Heritage Impact Assessment

Final Submission

259 Clemow Avenue
Ottawa, ON

Client #23-129 | RMA+SH #24057

Figure 7 – Site Plan with demolition shown in red (Shean Architects, 2024)

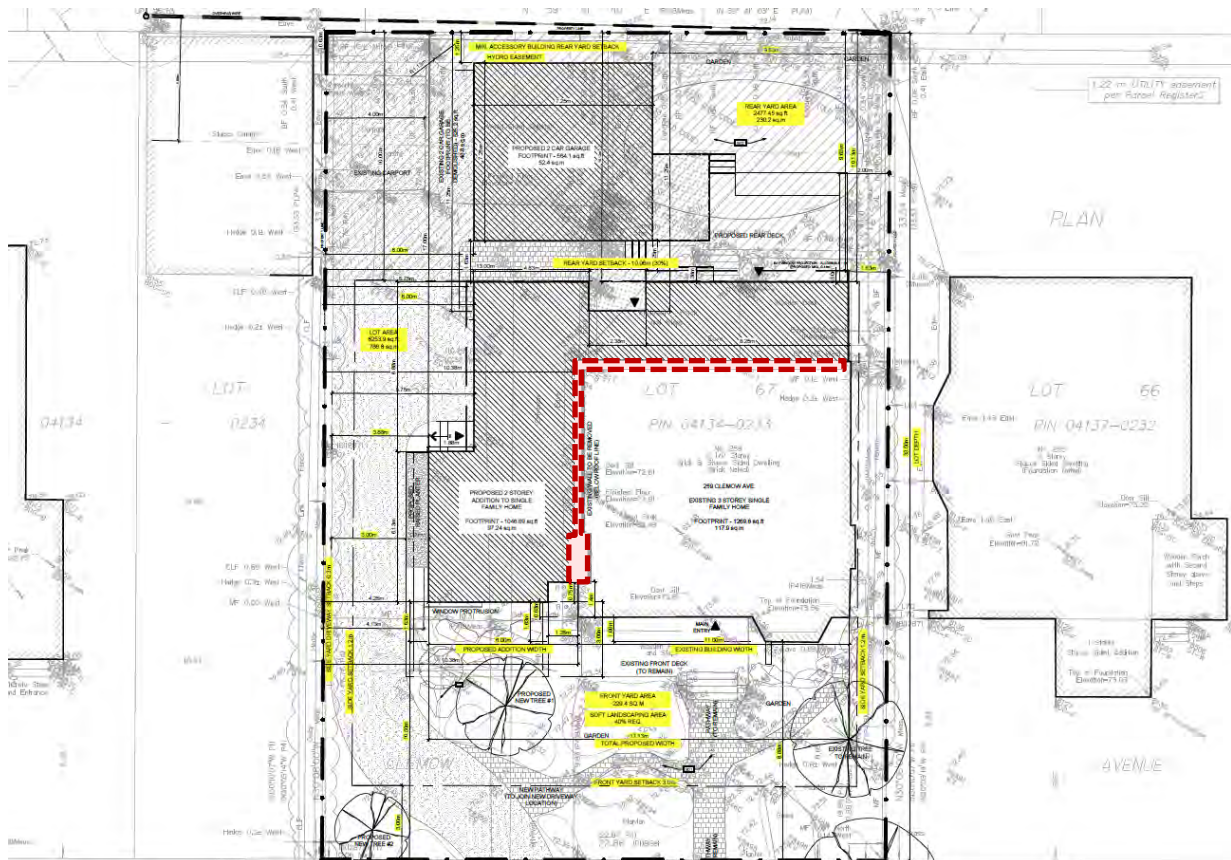
As noted in the proposed drawing set by Shean Architects, the proposed development includes demolition of two exterior walls, the existing 1-storey sunroom on the north façade, and the existing standalone 2-car garage at the rear of the house. The full north façade and the majority of the west façade, including the north chimney, are being demolished to allow for an open floorplan between the existing building and the new addition (see *Figure 7*). The stone foundation is also being partially demolished on the north and west facades to extend the footprint of the basement into the addition. Lastly, the roof and dormers are also being partially demolished to allow for a new skylight on the west façade, and a new balcony on the upper north façade.

Figure 14 – Proposed Site Plan with existing building in grey and additions in red (Shean Architects, 2024)

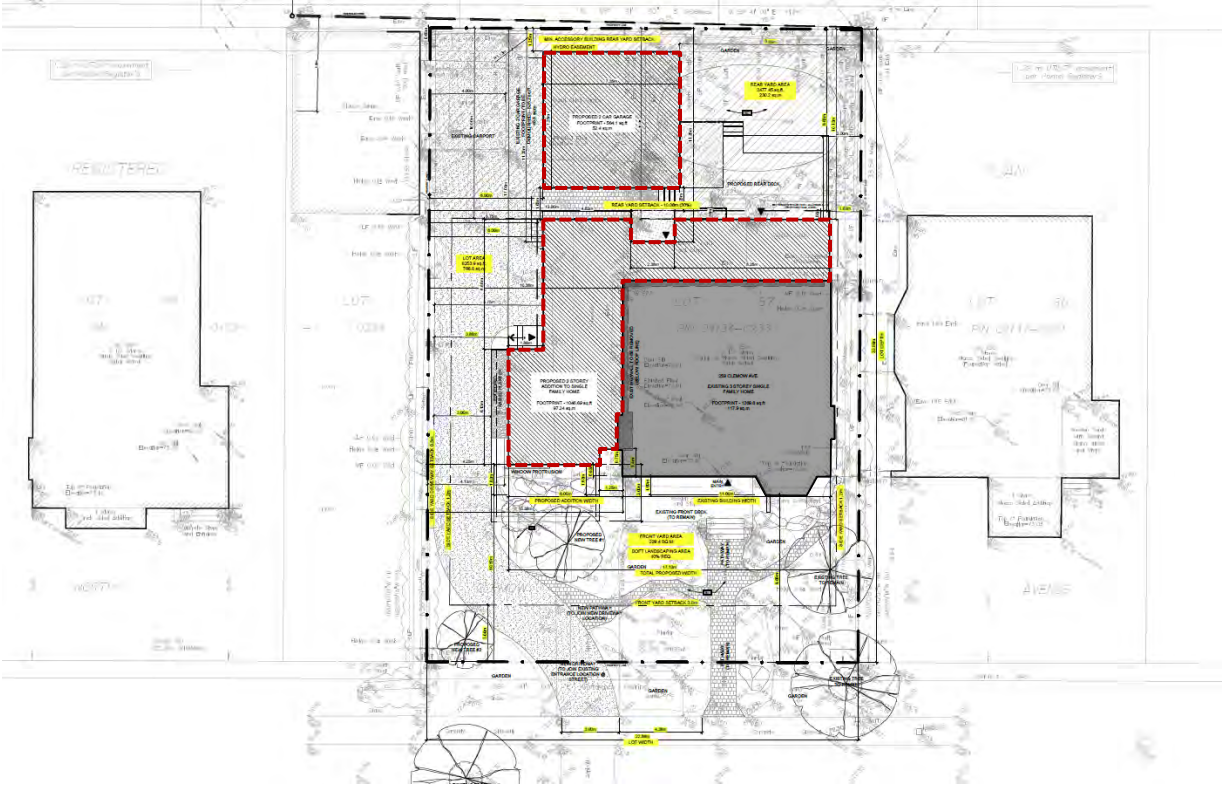
The final aspect of the proposed development is a modern 2-storey addition on the westerly side and northerly rear of the building, which will extend the footprint of the building and replace the existing sunroom on the rear of the building (see *Figure 14* to *Figure 29*). A glass reveal offsets the original building and new addition on the south façade. The height of the addition extends several feet above the roofline of the existing building with a taller “modern bay” on the southwest corner of the addition, meeting the mid-point of the existing bay. The sizing of the reveal and windows on the addition have been selected based on an analysis of the existing window widths (see *Figure 24*). A window well is also being added on the south façade to allow for large below-grade windows on the new basement level of the addition.

A new standalone 2-car garage with a green roof is being added in the rear yard to replace the existing garage building. A third integrated parking spot is also being added on the west façade of the building. The existing asphalt driveway is being replaced with a permeable driveway and relocated to accommodate the addition, a new rear deck is being added, wood fencing is being added along the west and north lot lines, and new pathways and landscaping are being added in the front yard.

Figure 25 – Proposed Landscape Plan (Shean Architects, 2024)

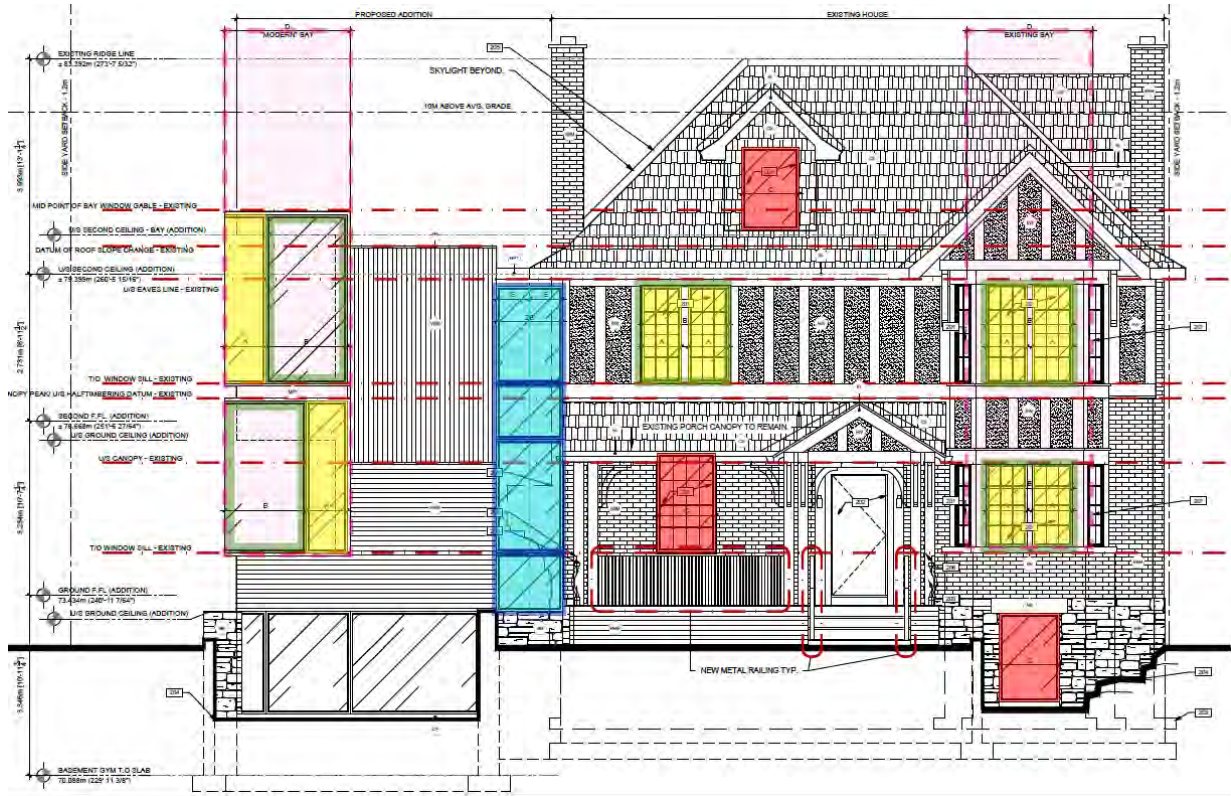
It is understood that the existing mature tree on the west side of the lot will not be retained as part of the proposed design, and two new deciduous trees are proposed as replacements. It is recommended that mature replacement trees be planted to reduce the time required for their visual impact to be restored.

The overall design of the front yard is generally considered to be compatible with the neighbourhood characteristics. However, while the heritage conservation district plan is supportive of fencing in the backyard, the addition of fencing on the west lot line that exceeds the front elevation of the house is not supported and warrants further consideration. Part of the heritage character of the district is the generous landscaping and uniform streetscaping that flows between lots; the introduction of a hardwall fence that extends to the front lot line is contrary to the intent of the district. Reducing this element back to the face of the house is considered to be more appropriate.

Figure 30 – Proposed Material Palette (Shean Architects, 2024)

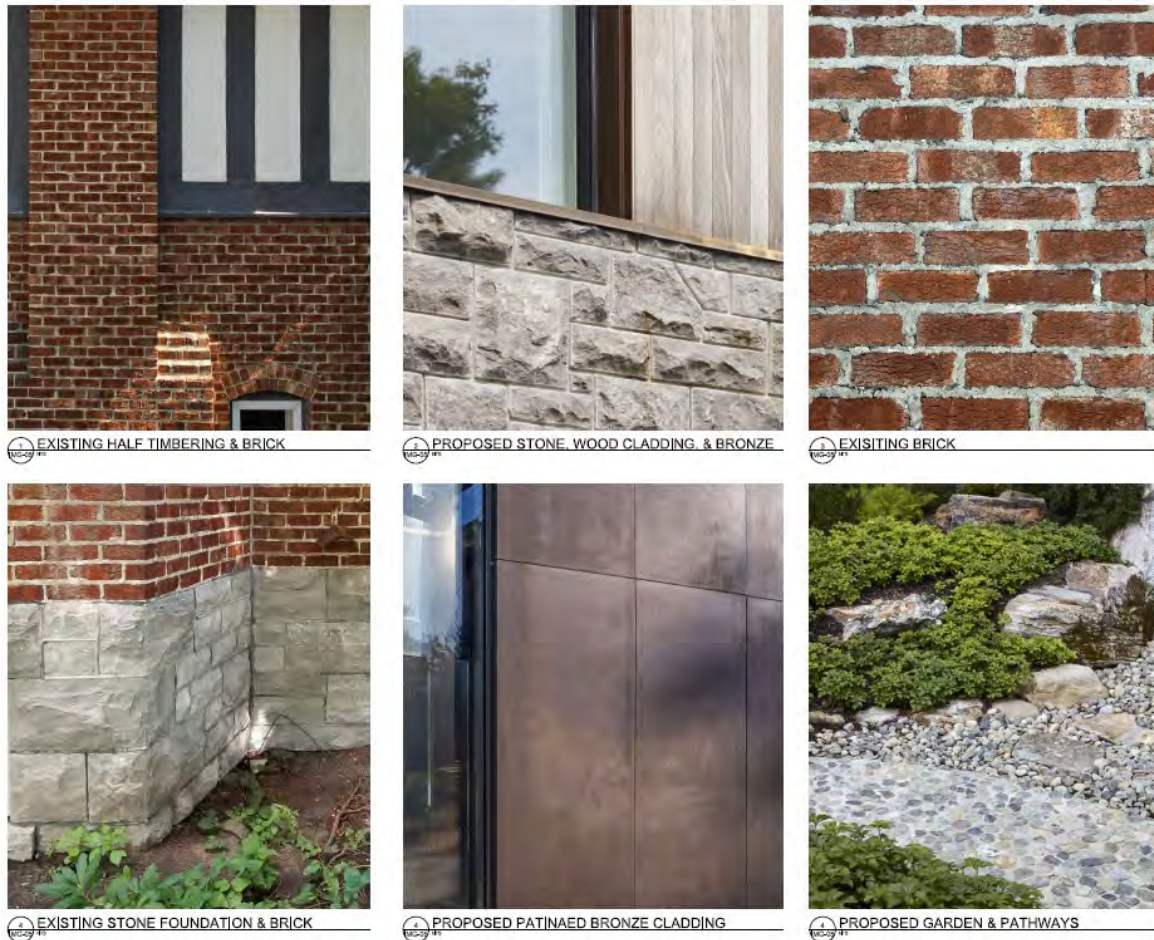
The material palette for this addition is comprised of torrefied wood siding, pre-finished patinated bronze panels, and new stone veneer at the foundation level to match the existing stone foundation (see *Figure 30*). The proposed windows are larger-scale versions of those proposed for the existing building, and are understood to be a combination of metal-clad wood casement and picture windows. The replacement doors are understood to be solid wood. New roofing on the addition is understood to be comprised of 2-ply modified bitumen.

The current scope of masonry work is not fully clarified in the design documents, and further detail should also be included for evaluation, such as repointing scope and proposed mortar type and colour. The proposal includes the addition of a window well on the south façade to accommodate a larger window; it is reasonable to assume that newly exposed foundation masonry will likely need to be repointed. Based on the age of the building, repointing may also be needed in other locations to ensure continued performance of the masonry façade.
